Basin Pump Station Improvements Phase II Project  
SAWS Job No. 15-6004  
Solicitation No. CO-00163

**ADDENDUM No. 2**

March 30, 2018

**C-127**

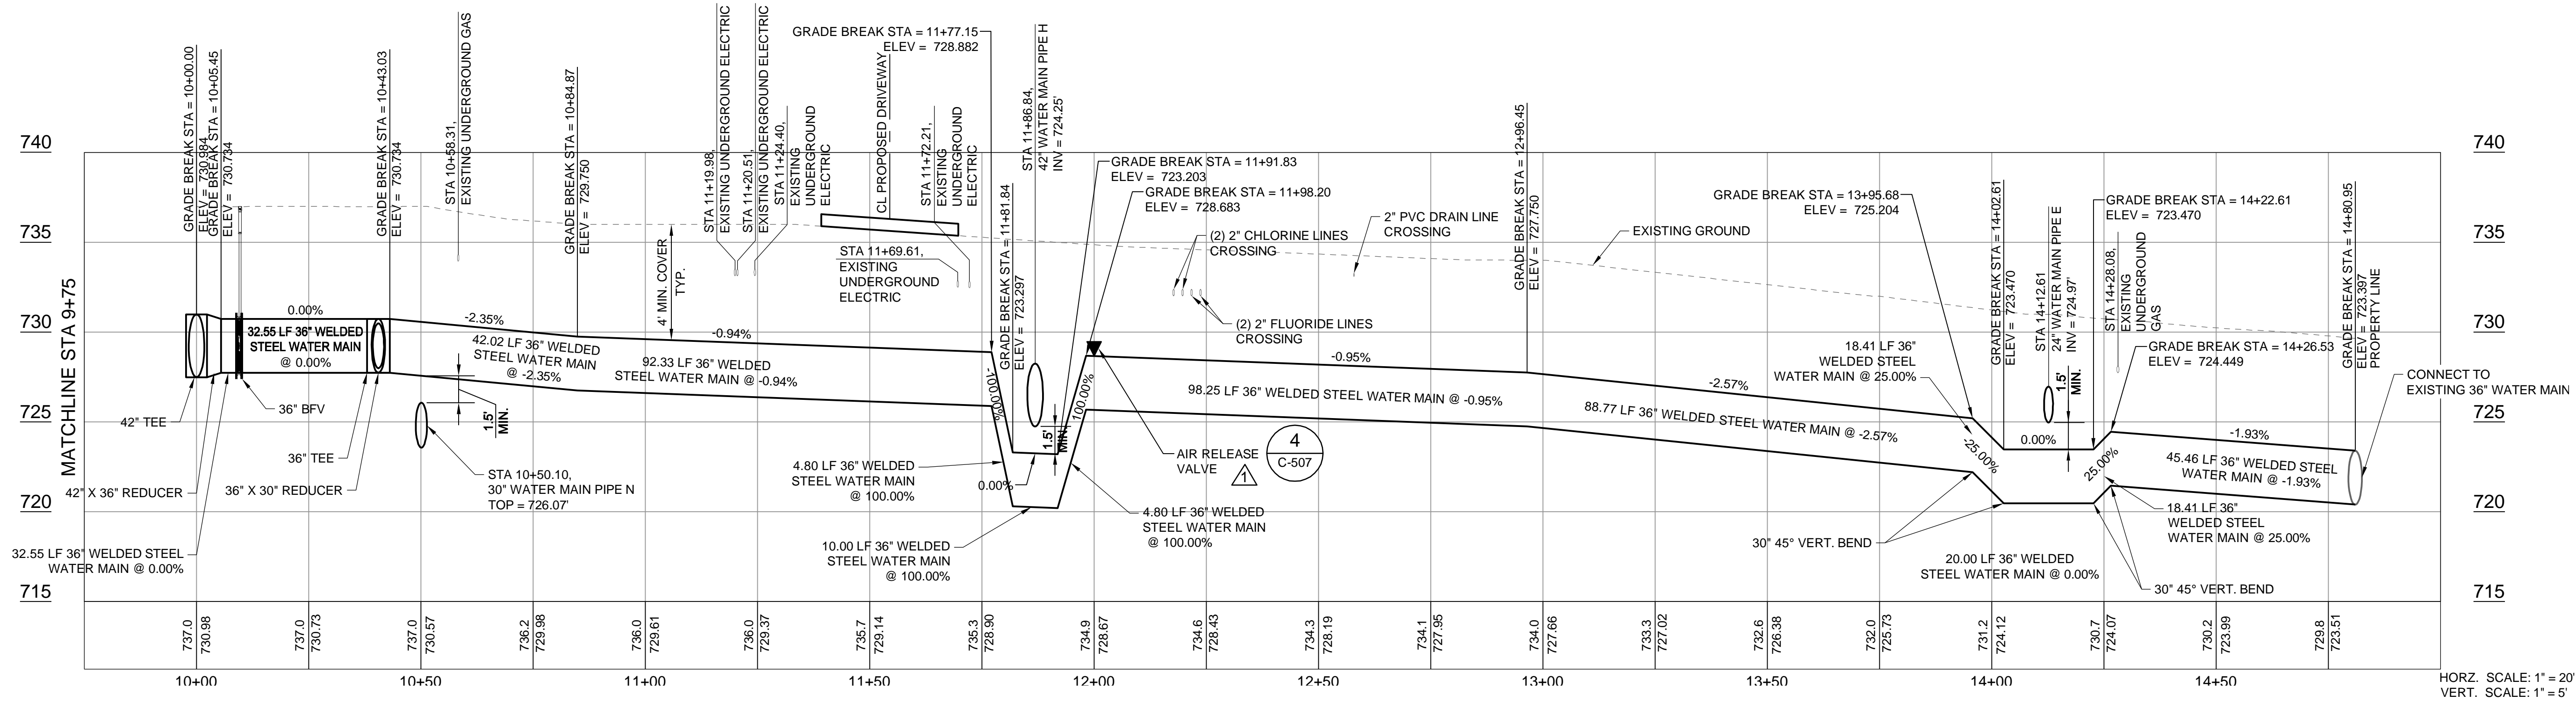
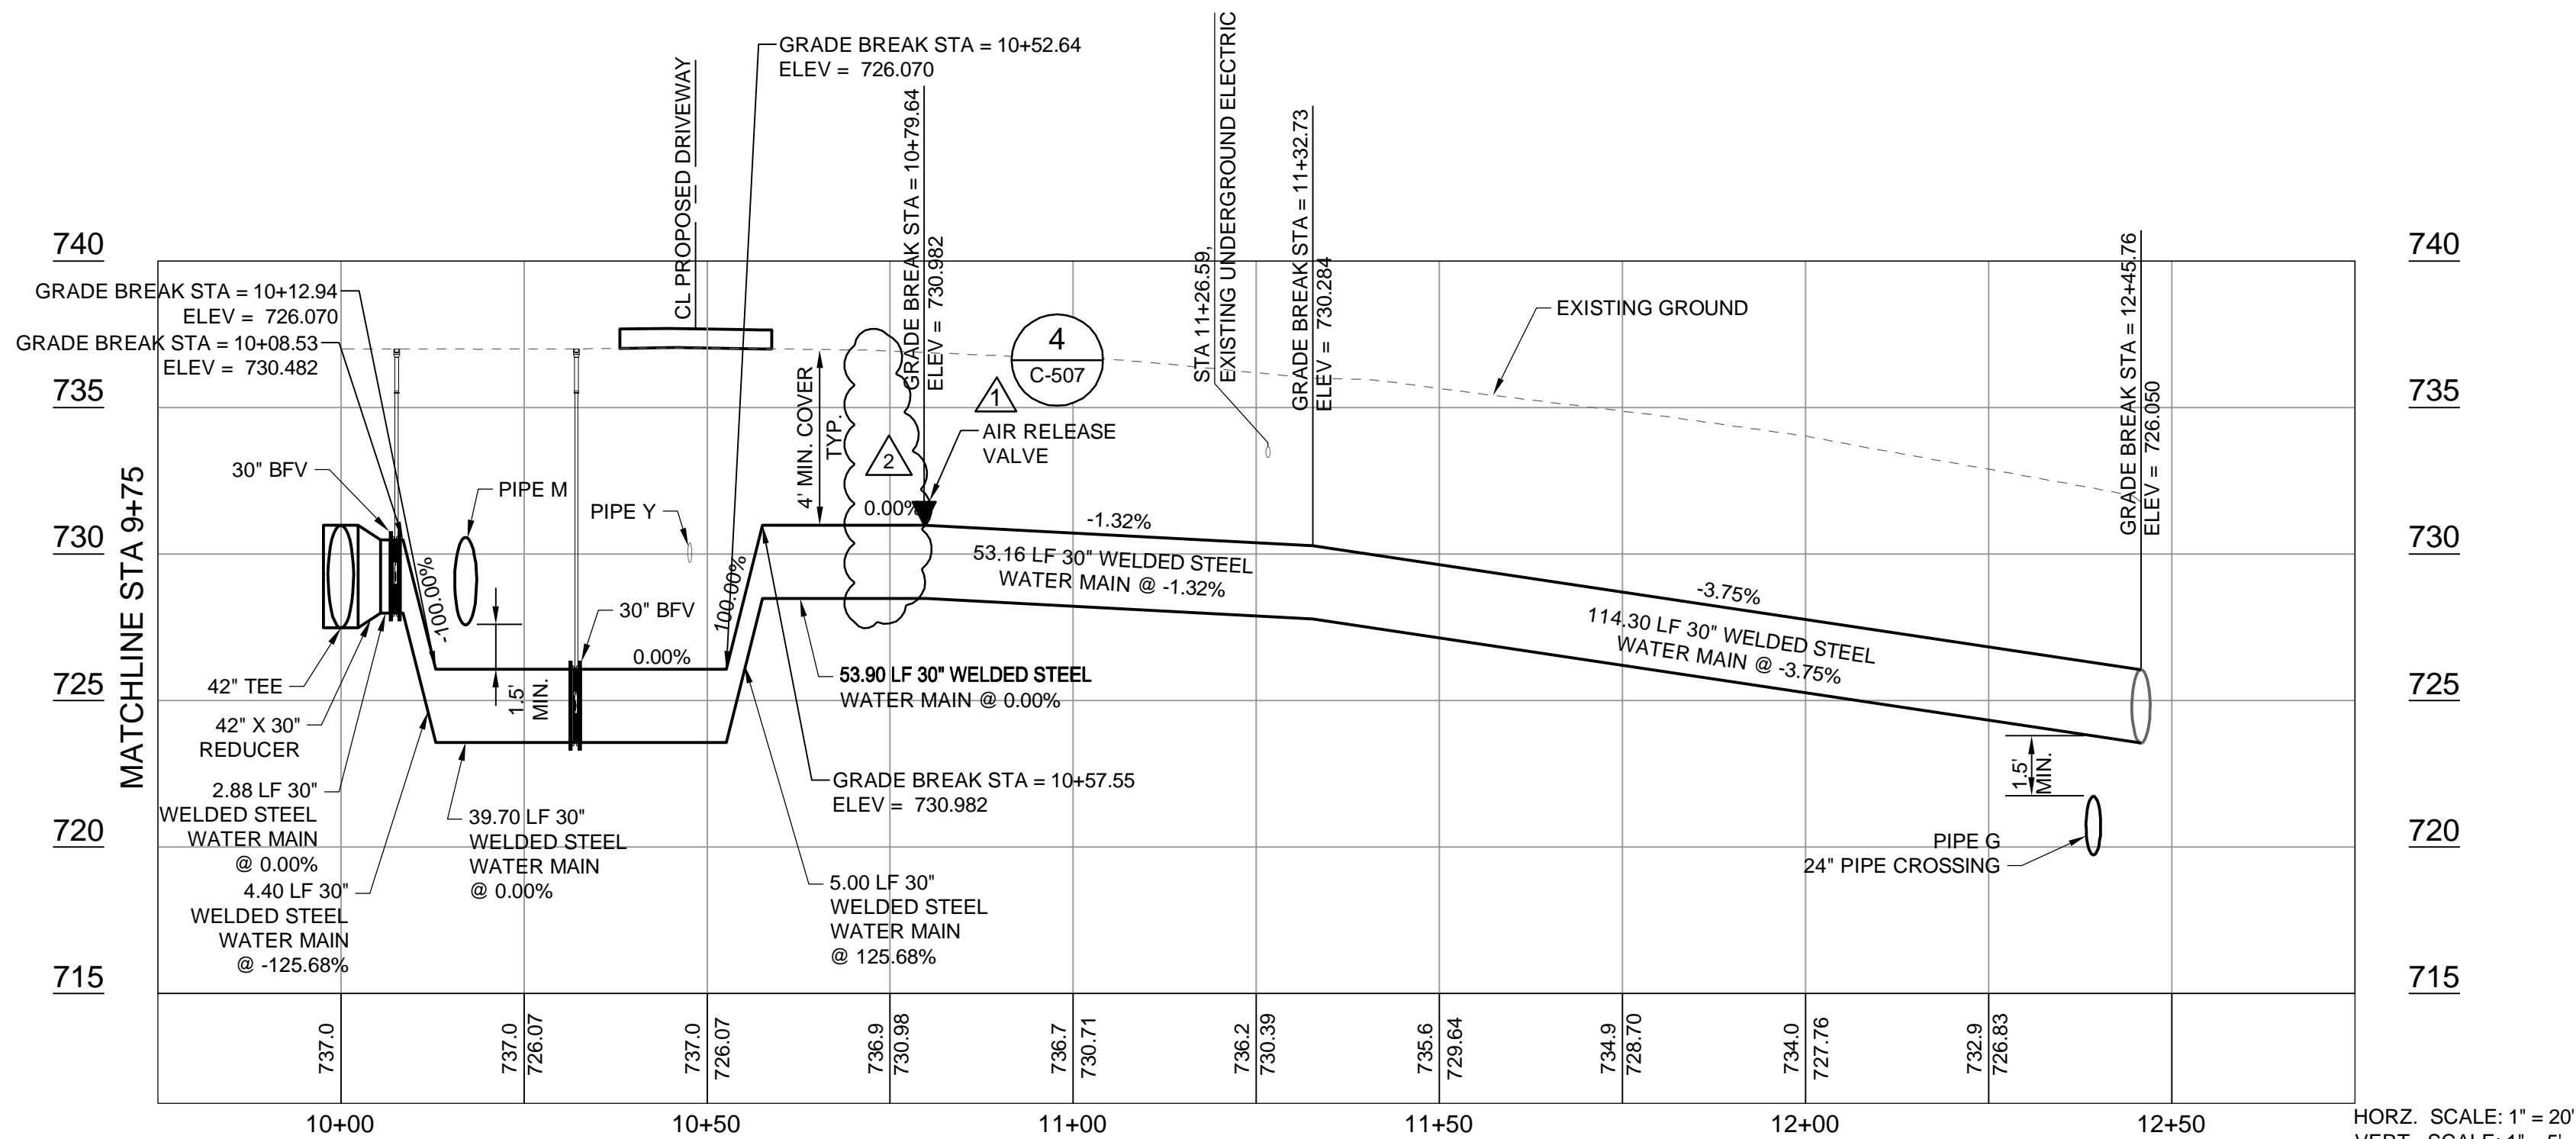
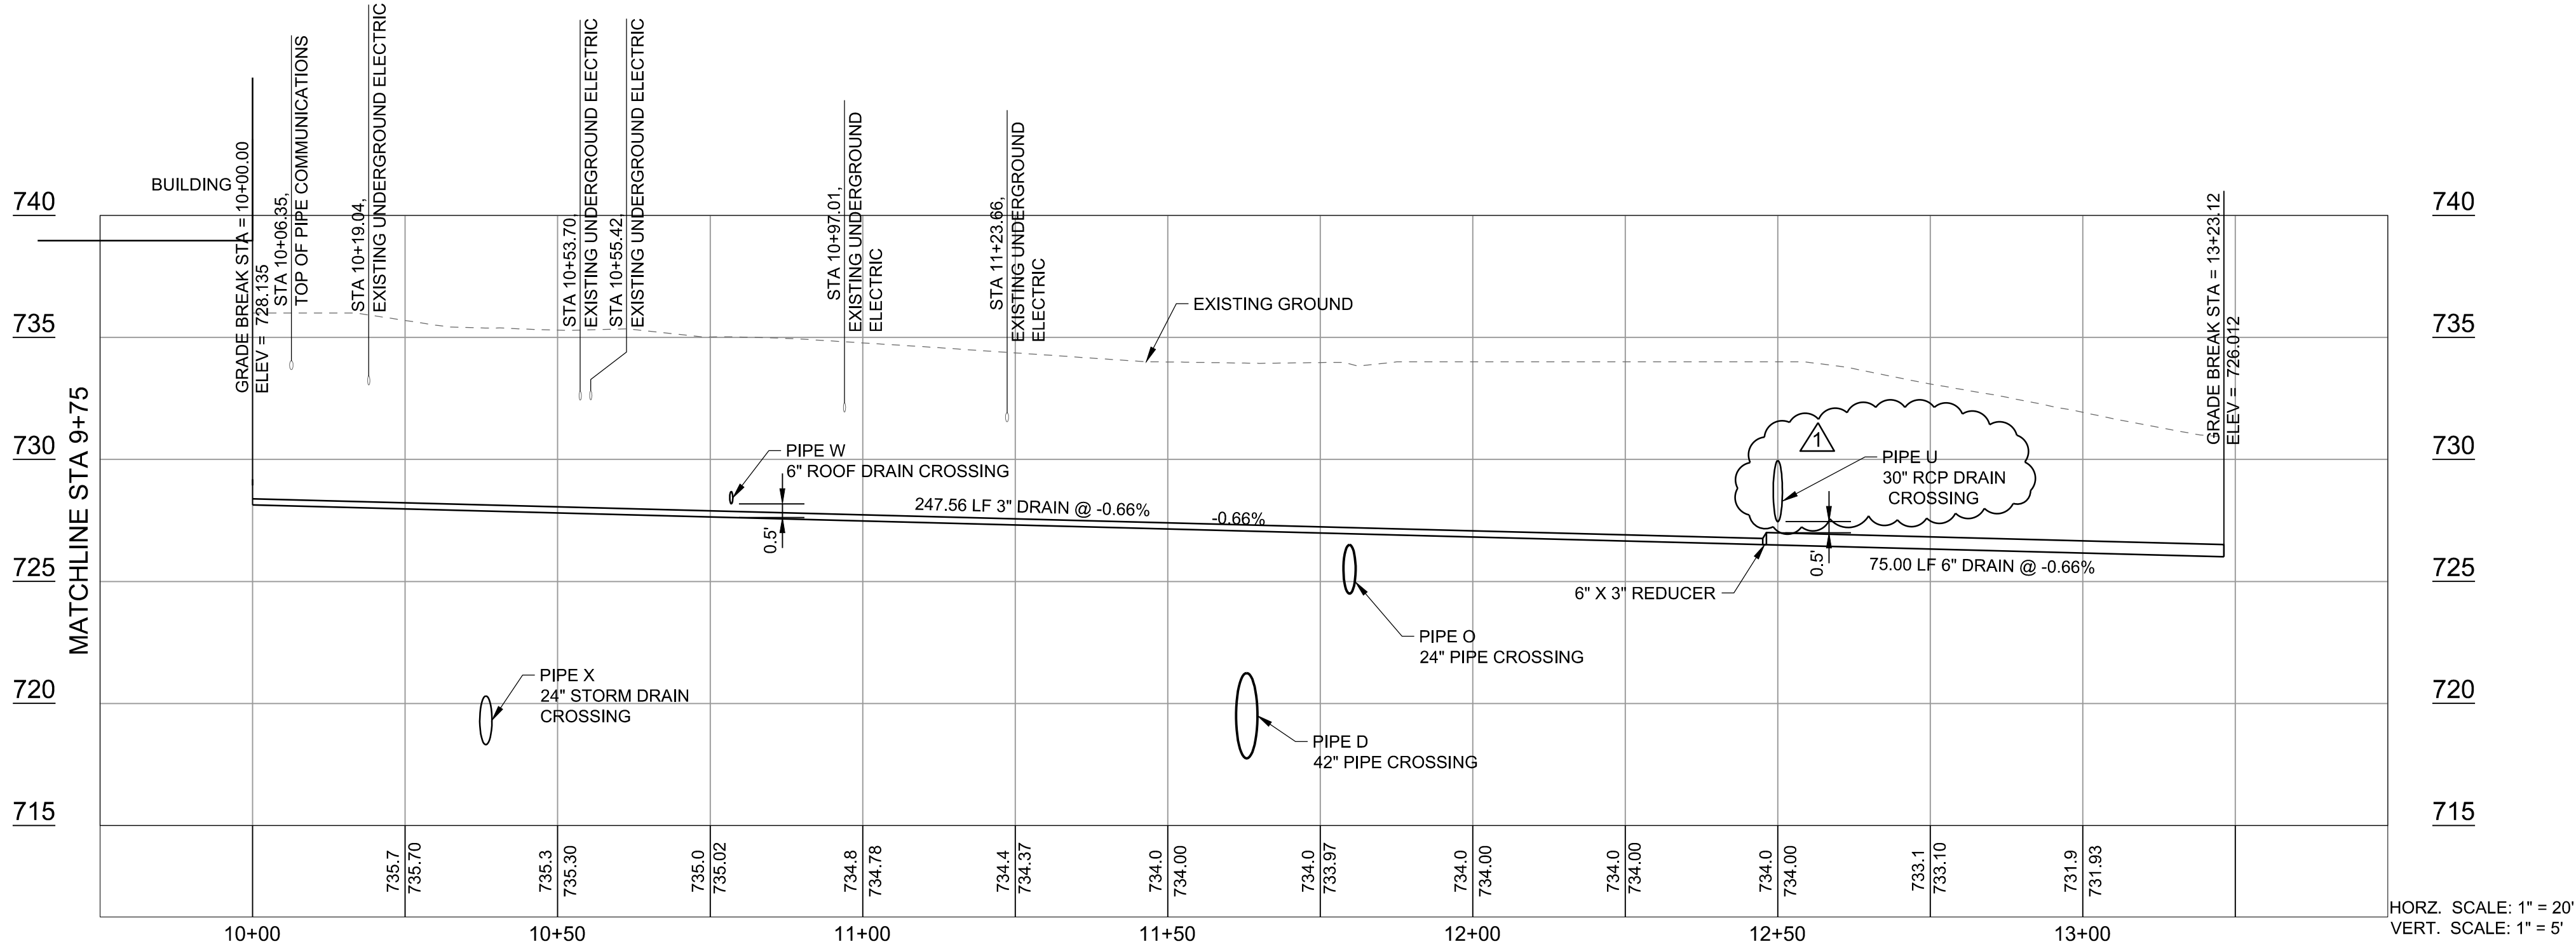
- 1.30.** The profile for 30" Water Line N (C-127) indicates three (3) butterfly valves within approximately 80 ft of pipe. This line on Drawing C-120 shows 100-BFV-15 and 100-BFV-16 and a water meter. On this drawing there are also water meters (WM) indicated on 42" Water Lines R and S, but the meters are not shown in their respective profiles on Drawing C-128.

**Response:** Water meter located on Pipe N, Pipe S, and Pipe R are not required. Refer to part 3, Modifications to the Drawings, Item 3.3 herein.

CONCRETE PAVEMENT SECTION

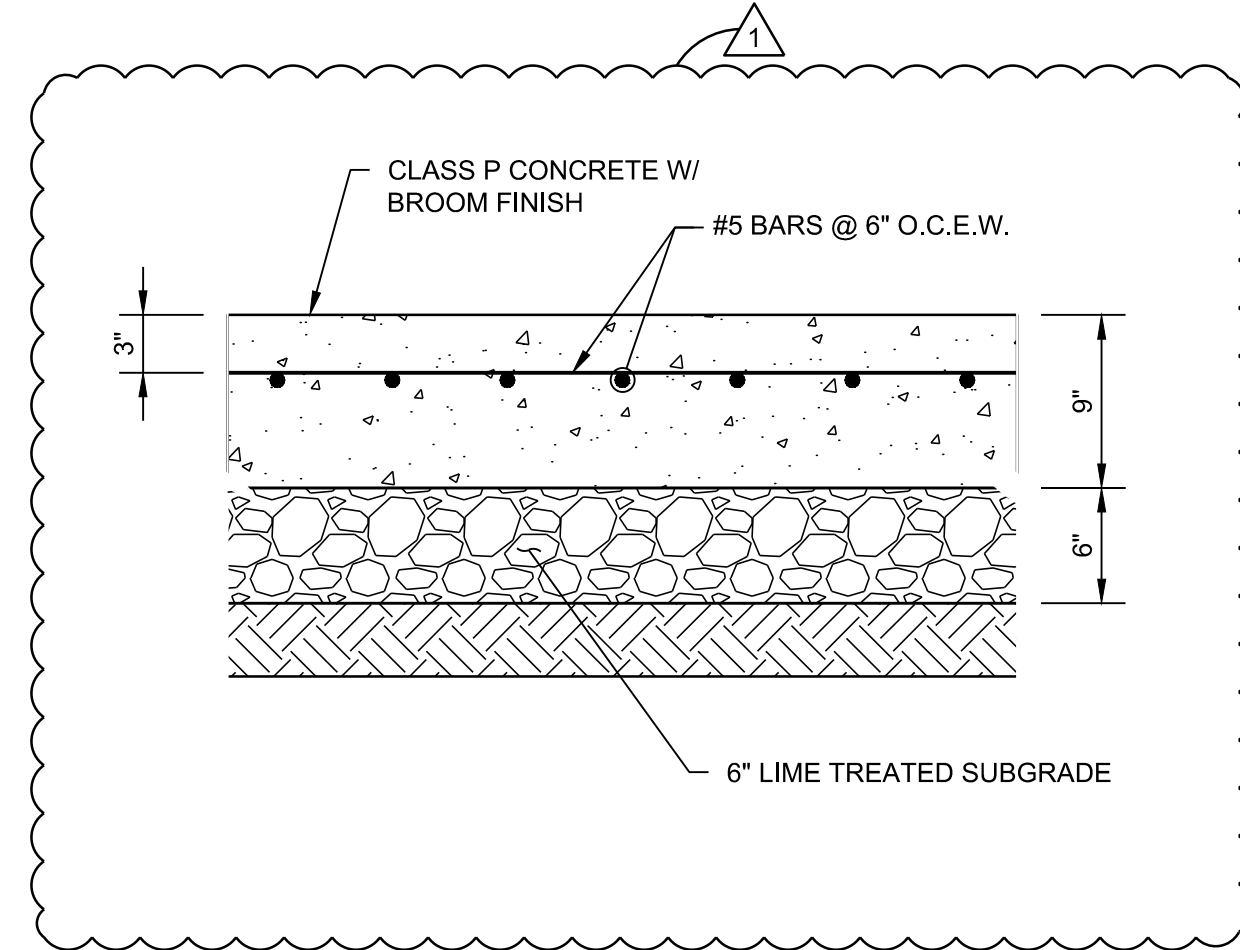
- 1.21.** Drawing C-502, Detail 2, provides information on the concrete pavement section. The pavement is 9” thick reinforced, but does not detail what the reinforcing is. Specification section 02510 3.2.C says: For concrete pavement, install size and length of reinforcing steel and pavement thickness indicated on Drawings. Please provide the reinforcement size and spacing required.

**Response:** Refer to part 3, Modifications to the Drawings, Item 3.9 herein.

EXPANSION JOINT

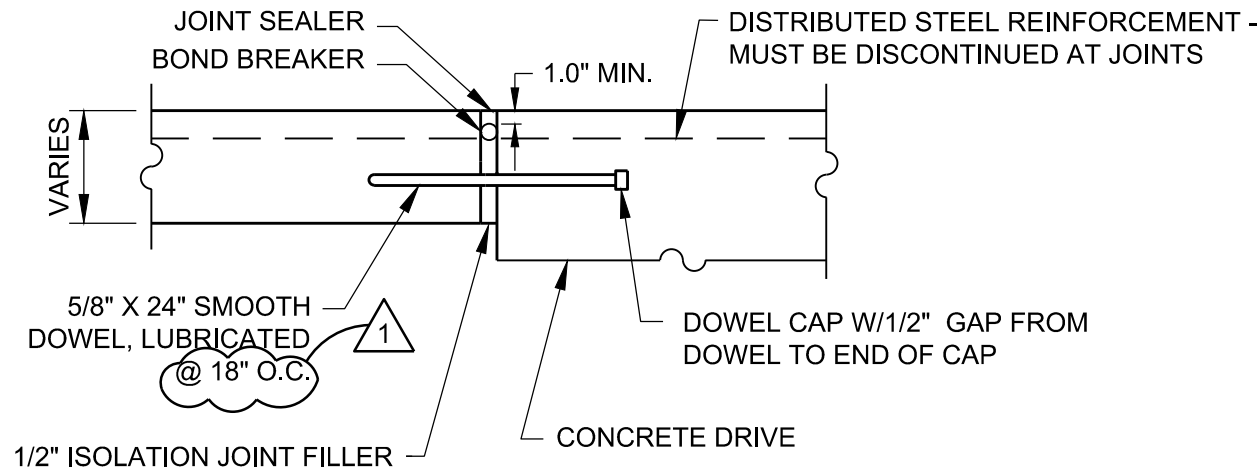
- 1.18.** Drawing S-302 indicates a ½” continuous expansion joint full height of containment wall, between the Chemical Building and the Hypo Bulk Storage Tank Building. The note is located on the southern tank elevated pad. Drawing C-301 indicates to construct an expansion joint per Detail 6/ C-502. Detail 6/ C-502 includes a slip dowel assembly and appears to indicate a joint between the new PCC drive and sidewalk, as concrete drive is indicated. Please confirm the correct detail for the location between the two buildings?

- 1.19.** Drawing C-502, Detail 6, what is the spacing of the smooth dowels? Detail 7, the reinforcement note points to what appears to be a smooth dowel like the one referenced in Detail 6, except without the cap. If this detail is to be utilized, please confirm size, length, spacing, and use location in an 8” section.

**Response:** There should not be dowels between the Chemical Building and the Hypo Bulk Storage Tank Building. A ½” continuous expansion joint full height of the containment wall is correct. Refer to part 3, Modifications to the Drawings, Item 3.9 and 3.11 herein.

**Response:** For expansion joints between sidewalk and 8” walls, dowels shall be 5/8-inch by 18-inch with 6-inches into the wall and remainder in the sidewalk and capped, spaced on 18-inches on center. All other expansion joint dowels to be spaced at 18-inches on center.
